FILING NO. 4  
ROADWAY & STORM IMPROVEMENT PLANS

TRAILS AT ASPEN RIDGE			
FILING NO. 4 ROADWAY & STORM IMPROVEMENT PLANS			
ROADWAY PLAN & PROFILE			
DESIGNED BY:	CAG	SCALE	DATE ISSUED:
CHECKED BY:	NMS	HORIZ 1"=40' VERT. 1"=8'	JUNE 2021
SHEET			5 OF 32
RD01

TRAILS AT ASPEN RIDGE			
FILING NO. 4 ROADWAY & STORM IMPROVEMENT PLANS			
STORM DRAIN PLAN & PROFILE			
DESIGNED BY: JTS	SCALE	DATE ISSUED: JUNE 2021	DRAWING No. SD03
DRAWN BY: BAS	HORIZ 1" = 40'		
CHECKED BY: NMS	VERT 1" = 5'	SHEET 26 OF 32

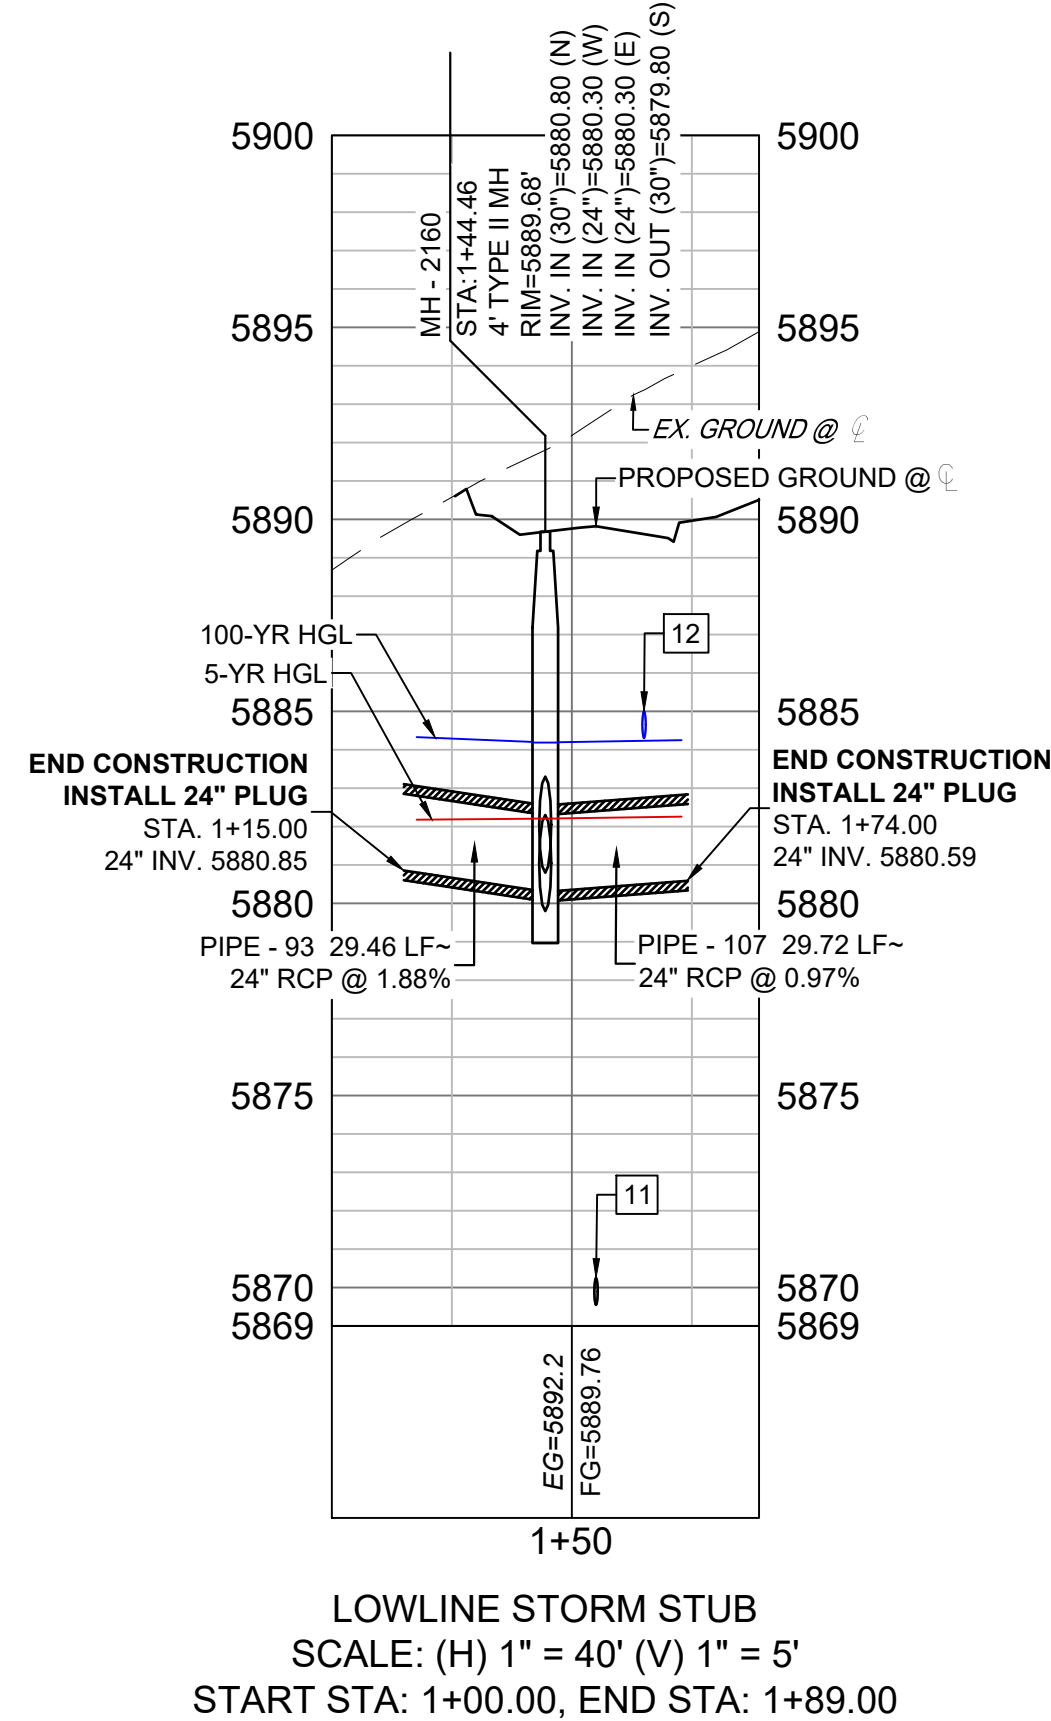
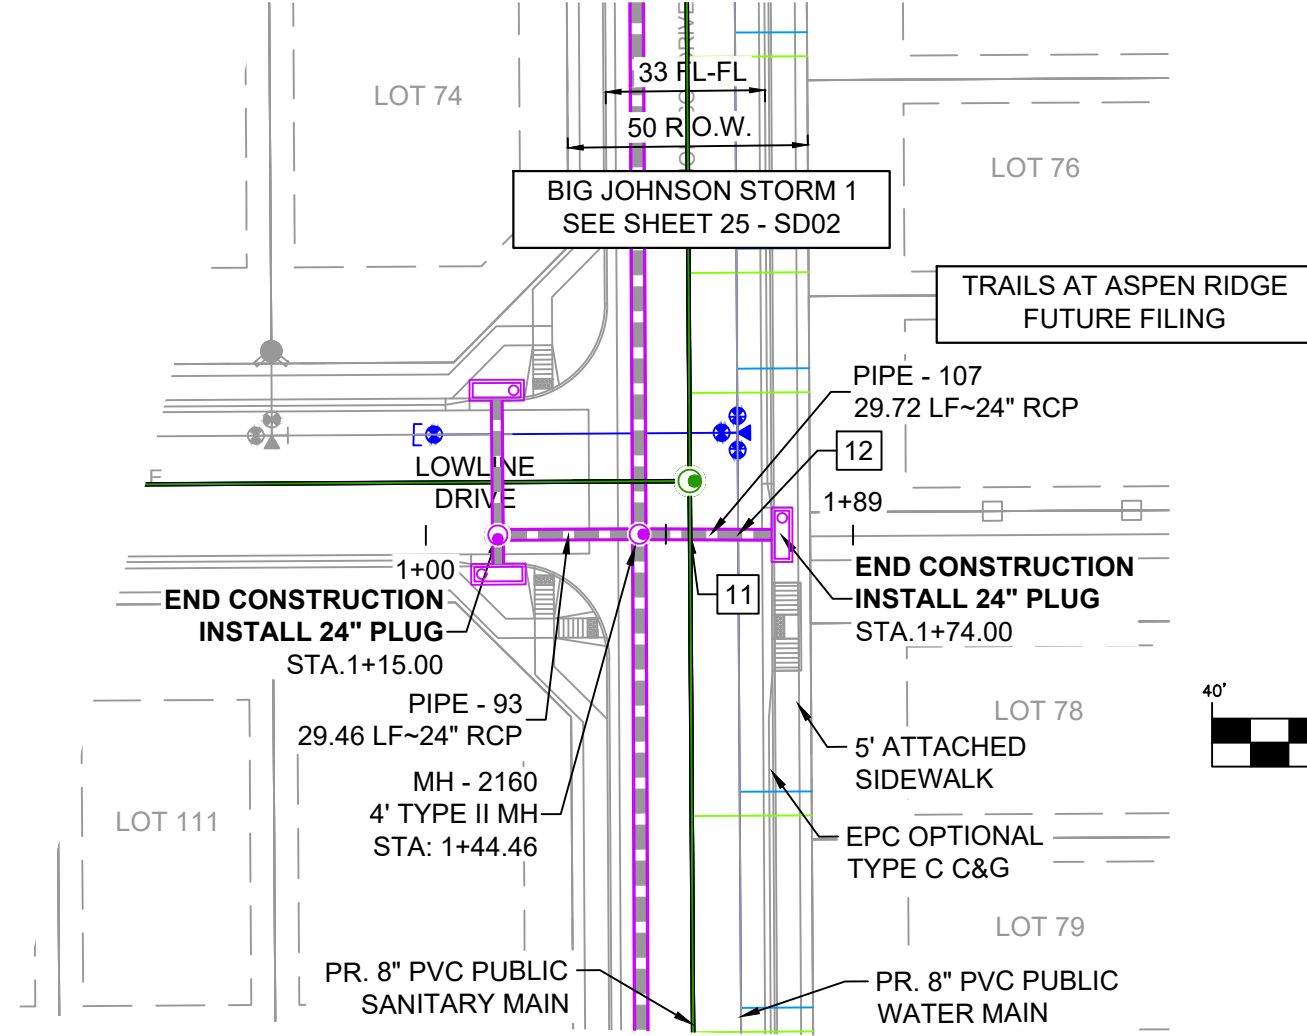
Update to specify the concrete type used. See the deviation request redline comments.

TRAILS AT ASPEN RIDGE			
FILING NO. 4 ROADWAY & STORM IMPROVEMENT PLANS			
POND PLAN			
DESIGNED BY:	JTS	SCALE	DATE ISSUED:
CHECKED BY:	LCB	HORIZ. 1"=30' VERT. 1"=5'	JUNE 2021
SHEET			29 OF 32
DRAWING No.			DT01

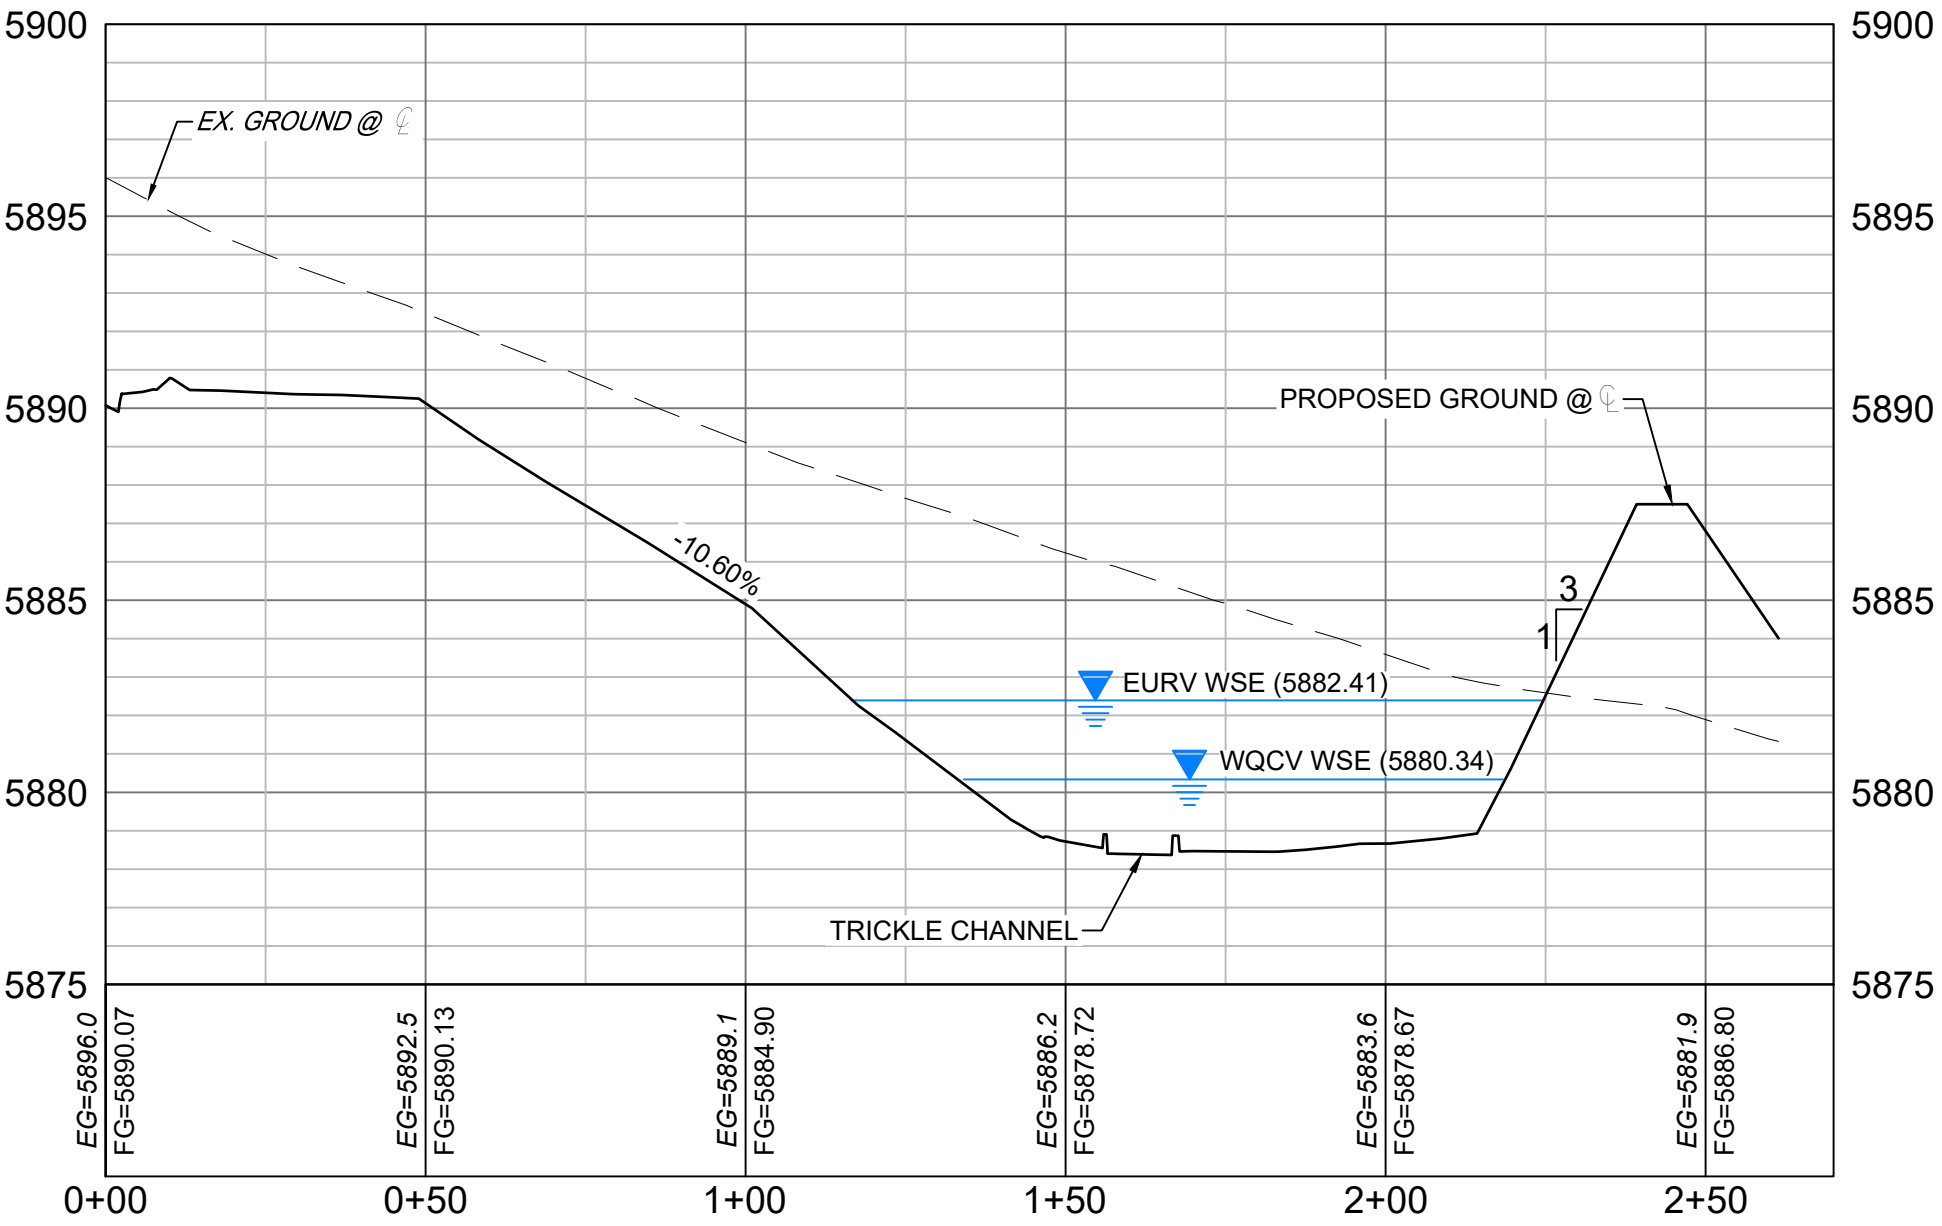
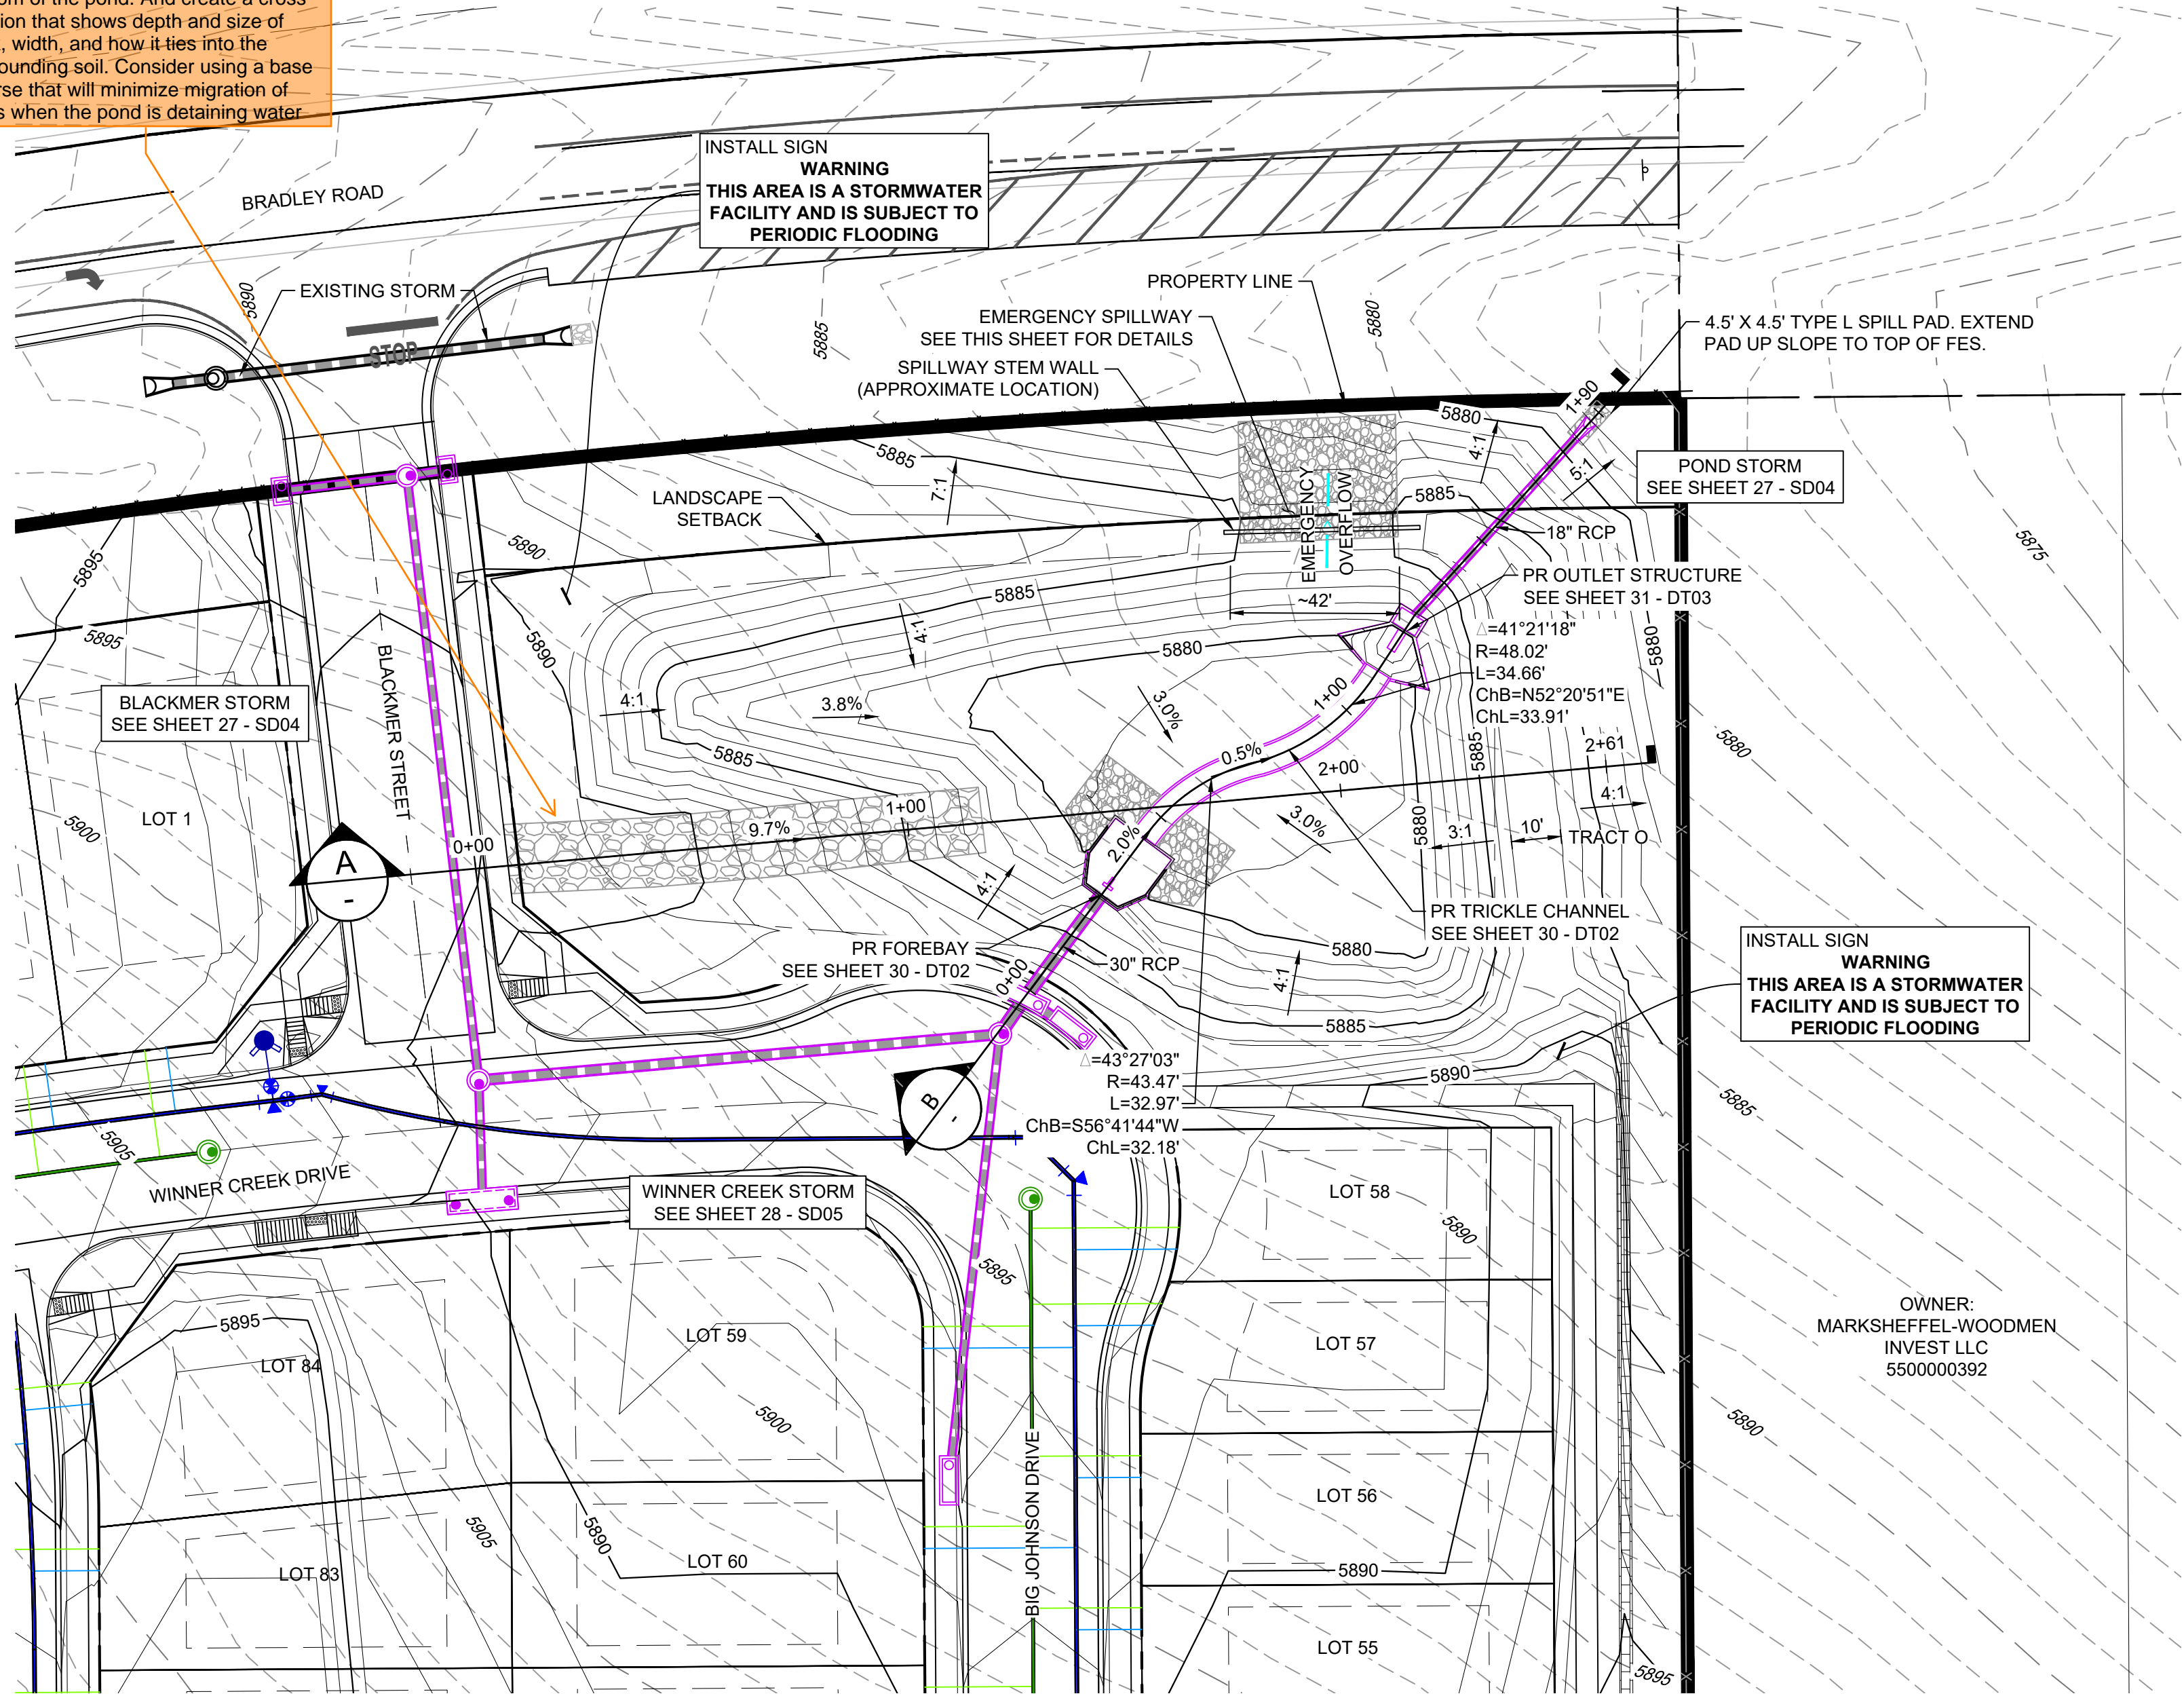
Label as stabilized maintenance access road (15ft wide min). And extend it to the bottom of the pond. And create a cross section that shows depth and size of rock, width, and how it ties into the surrounding soil. Consider using a base course that will minimize migration of fines when the pond is detaining water
